**DATE:** October 23, 2008

**SUBJECT: Addendum No. 4**  
**US 50 HOV Lanes Phase 1 El Dorado Hills to Bass Lake Grade**  
**(Contract No. 53110)**

**TYPICAL CROSS SECTIONS**  
**X-3A**  
 NO SCALE

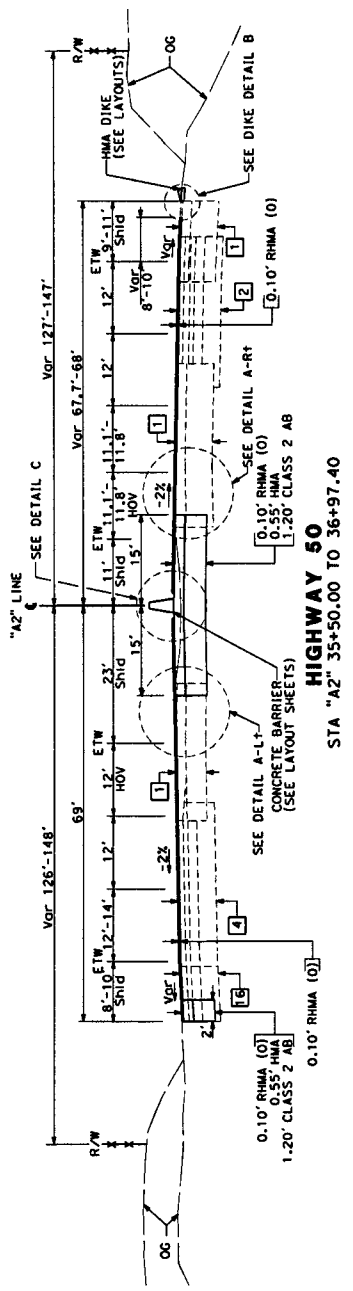
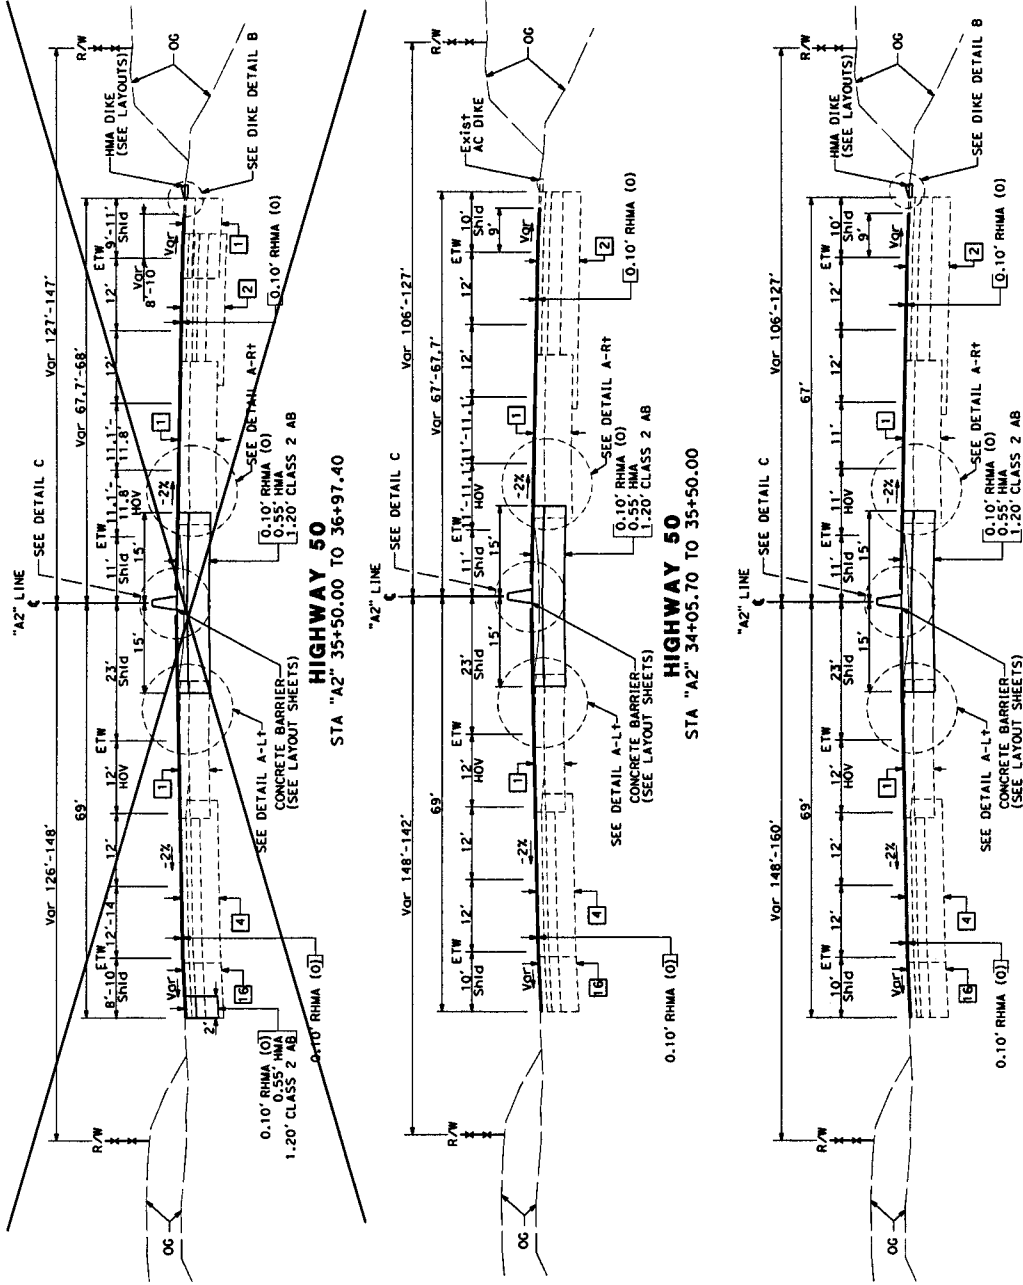
4.02	New Plan Sheet 4A	<b>Project Plan Sheet 4A -</b> A plan sheet is added to the project plans as sheet 4A of 451 - "TYPICAL CROSS SECTIONS X-3A". The typical section for Highway 50 Station "A2" 35+50.00 to 36+97.40 is shown on this sheet including a westbound shoulder detail for Highway 50 Station "A2" 35+50.00 to 47+75.00.

**ADDED PER ADDENDUM No.4 DATED OCTOBER 22, 2008**

TYPICAL CROSS SECTIONS  
 NO SCALE  
 X-3

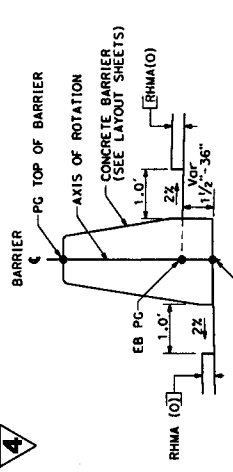
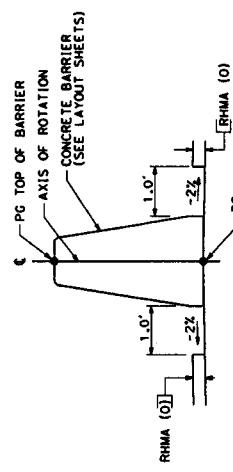
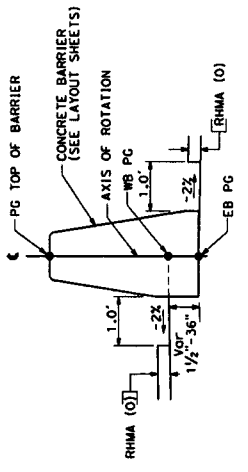
ADDENDUM ITEM NO.	PAGE OR DRAWING NO.	DESCRIPTION OF CHANGE
4.01	Plan Sheet 4	<b>Project Plan Sheet 4 -</b> "TYPICAL CROSS SECTIONS X-3", plan sheet 4 of 541, is replaced. The replacement sheet deletes the typical section for Highway 50 Station "A2" 35+50.00 to 36+97.40.

4 REVISED PER ADDENDUM No.4 DATED OCTOBER 22, 2008
